RE: Appeal of Certificate of Appropriateness:  
Hearing – October 3, 2022  
4512-4518 Sycamore St., Case No. CA212-354(RD)

**4512-4518 SYCAMORE  
STREET  
APPEAL  
CA212-354(RD)**

**City Plan Commission  
Hearing  
01/05/2023**

## SASH - EXPLODED VIEW

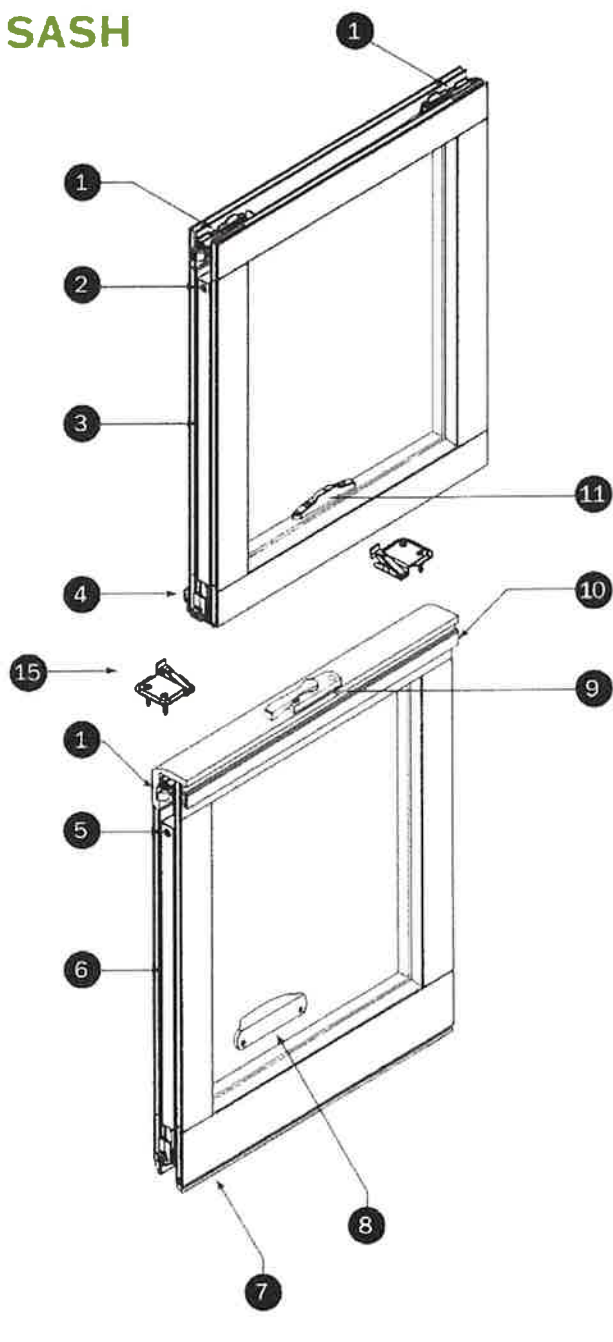
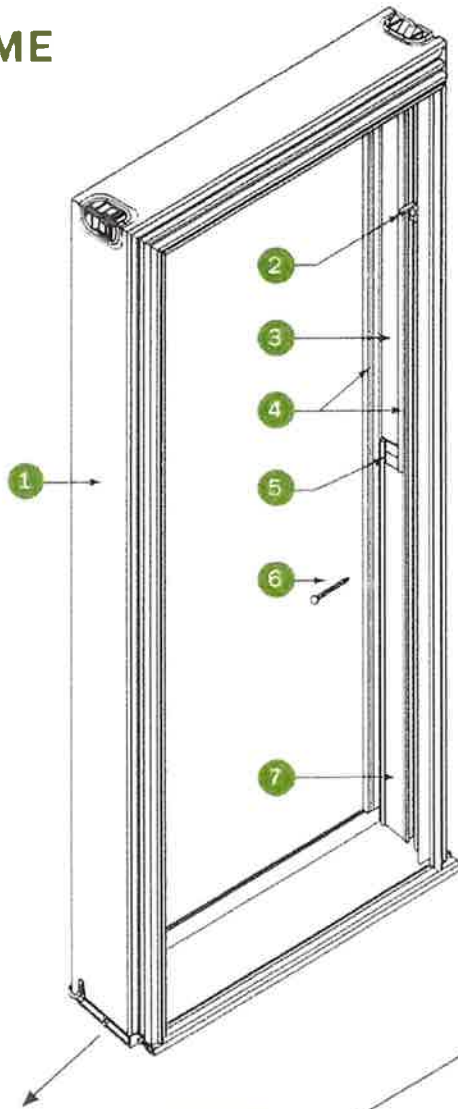
1                   Proceedings  
2           don't see on the detail that's provided  
3           that -- it looks like the meeting sash  
4           is the same dimension as the side rail  
5           sashes and the top rail sashes. I don't  
6           see a difference between your meeting  
7           rail sash. That's a very prominent  
8           feature on historical windows, interior  
9           windows, and I don't see that.

14                   COMMISIONER CUMMINGS: No, I'm  
15           talking about the bottom sash. There's  
16           also indications of differences on the  
17           thickness of the meeting sash, but let's  
18           just talk about the bottom sash. What's  
19           your dimension on your bottom sash? And  
20           I also don't see a sill detail that was  
21           called out, and you had three choices on  
22           the windowsills.

11 COMMISSIONER CUMMINGS: Correct.  
12 It doesn't seem like there's a  
13 difference between the bottom sash  
14 dimension and the side dimension.
